Gulf States Toyota, Inc.  
1375 Enclave Parkway  
Houston, TX 77077

Subject: Safety Recall 15R1 – **Remedy Notice**  
Certain 2015 Toyota Sienna vehicles equipped with  
Non-Toyota Rear Seat Entertainment Package

**SAFETY RECALL CAMPAIGN 15R1**

**Certain 2015 Toyota Sienna Vehicles Equipped  
with Non-Toyota Rear Seat Entertainment Package**

Figure 2

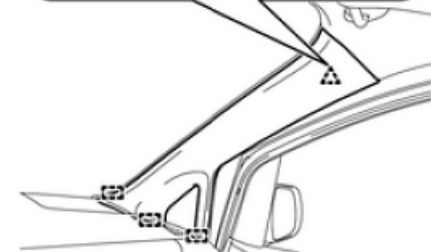
- c) Disengage the Front Pillar Garnish Clip by pressing the 2 tabs indicated by the arrows in the illustration. (Figure 2).

Figure 3

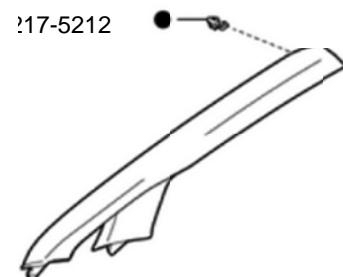
- a) **Install a new Front Pillar Garnish Clip (P/N 62217-52120) to the Front Pillar Garnish RH (Figure 3).**

**Orient clip so that the tab aligns to the notch in the Garnish.**

Figure 4

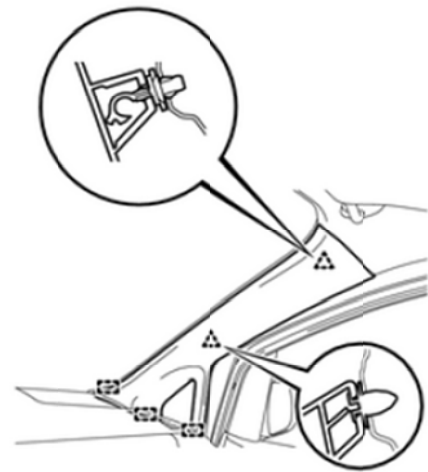
- b) Engage the 3 guides, clip, and Front Pillar Garnish Clip to install the Front Pillar Garnish RH. (Figure 4)
- c) Check the fit, form, and finish of the installation including no damage to the headliner area.
